FARRAGUT MUNICIPAL PLANNING COMMISSION
AGENDA

April 15, 2021 – 7:00 p.m.

9. **Discussion and public hearing on a site plan for the Farragut Town Center at Biddle Farms, Parcels 3.02, 3.03, 3.10, and a portion of 3.19, Tax Map 143, 11230 Kingston Pike, 11240 Kingston Pike, 133 Concord Road, 37.08 Acres, Zoned PCD and FPD (CHM, LLC, Applicant)**

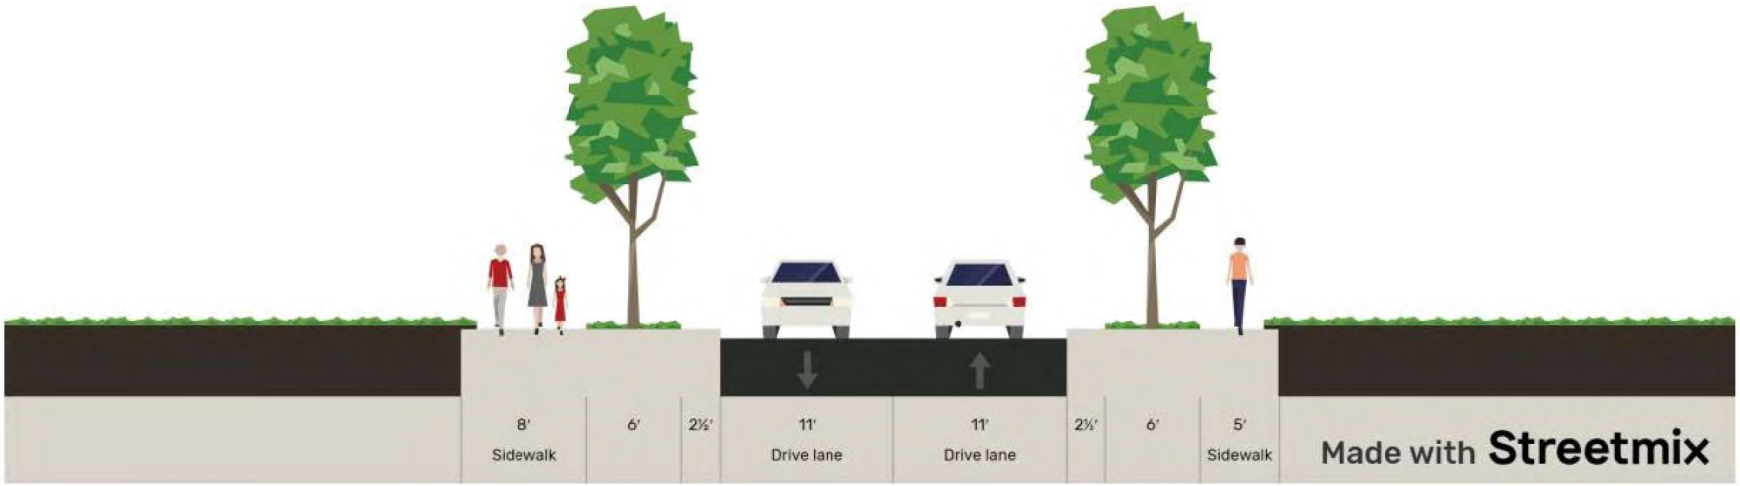
This cross section does not fit within a standard 50-foot ROW (+2 feet)
